To: Gregory Czumak/ PCTEST TCB
From: Mr. Andrew Bachler/ MOTOROLA Inc.

Applicant: Motorola, Inc.
Date: March 29, 2006

Subject: Request for additional information regarding FCC ID: IHDT56GE1 (Portable PCS CDMA transceiver)

CDMA 1900 – Upper Band Edge – Channel 1175 (1908.75 MHz)

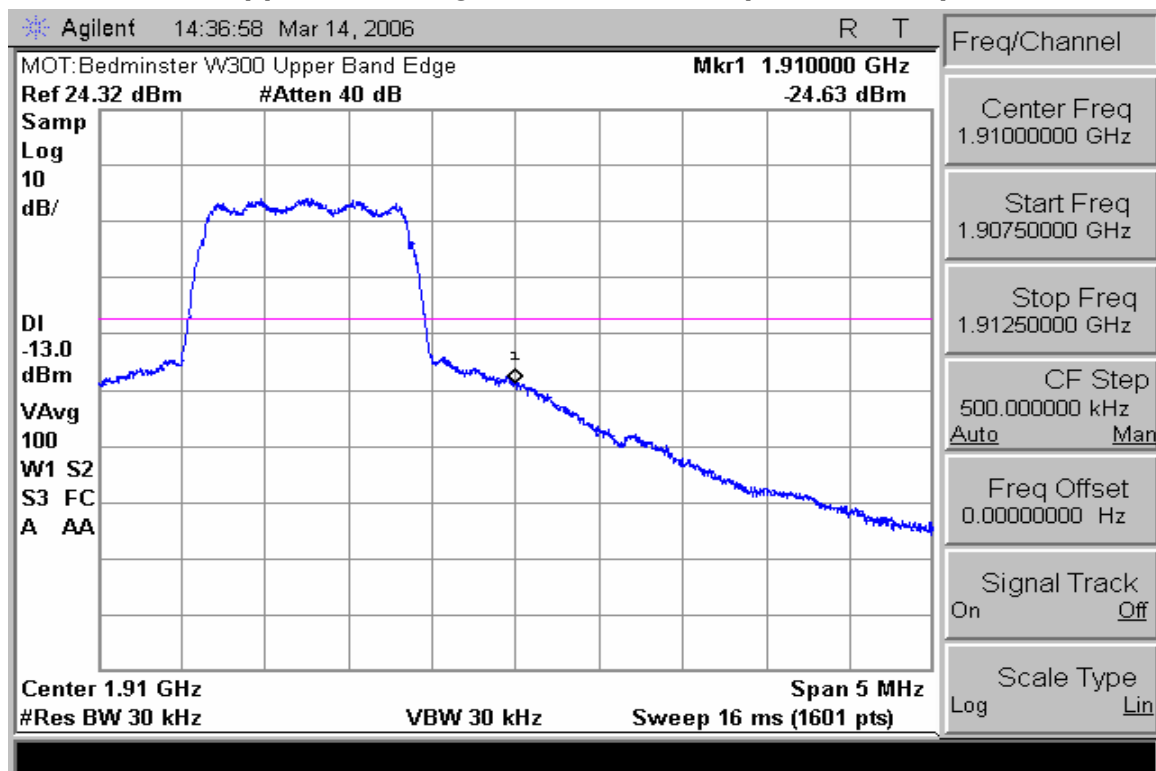
3. Please submit the PCS upper bandedge plot.

RESPONSE:

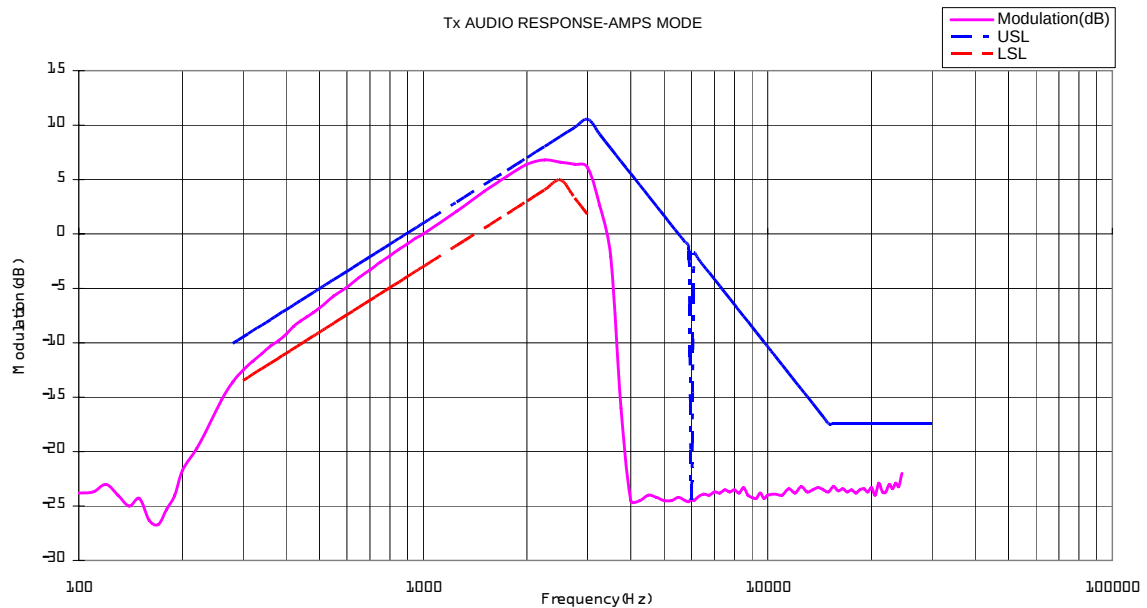
4. Please indicate the spec an settings used to perform cellular CDMA occupied bandwidth and band edge measurements.

Plot	Equipment Settings					
	Resolution Bandwidth (kHz)	Video Bandwidth (kHz)	Sweep Points (#)	Trace Mode	Detector	Samples (≥ #)
Reference Plot - CDMA 800	3000	Auto	2001	Max Hold	Peak	100
OCBW - CDMA 800	30	Auto	1601	Max Hold	Peak	100
Lower Band Edge - CDMA 800	1	Auto	2004	Max Hold	Peak	30
Upper Band Edge - CDMA 800	1	Auto	2004	Max Hold	Peak	30
Reference Plot - CDMA 1900	300	Auto	1001	Max Hold	Peak	30
OCBW - CDMA 1900	3	Auto	1001	Max Hold	Peak	30
Lower Band Edge - CDMA 1900	1	Auto	2004	Max Hold	Peak	30
Upper Band Edge - CDMA 1900	1	Auto	2004	Max Hold	Peak	30

Notes: 1) When the video bandwidth is set to Auto the video bandwidth self adjusts for ³ the resolution bandwidth.
 2) The plotted data shown for the band edge measurements is representative of data taken with a true 3 kHz resolution bandwidth filter. The raw data was taken using a 1 kHz resolution bandwidth and was integrated to produce a response representative of data taken using a true 3 kHz resolution bandwidth filter.

Frequency Deviation with Compander On

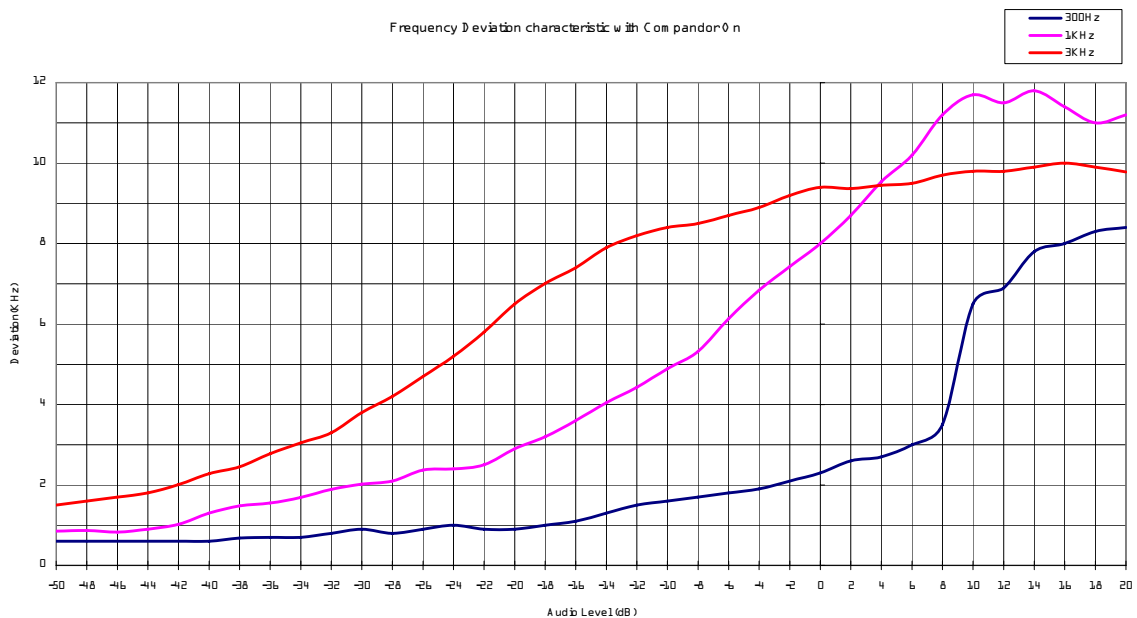
5. Please provide the required AMPS frequency response plots.
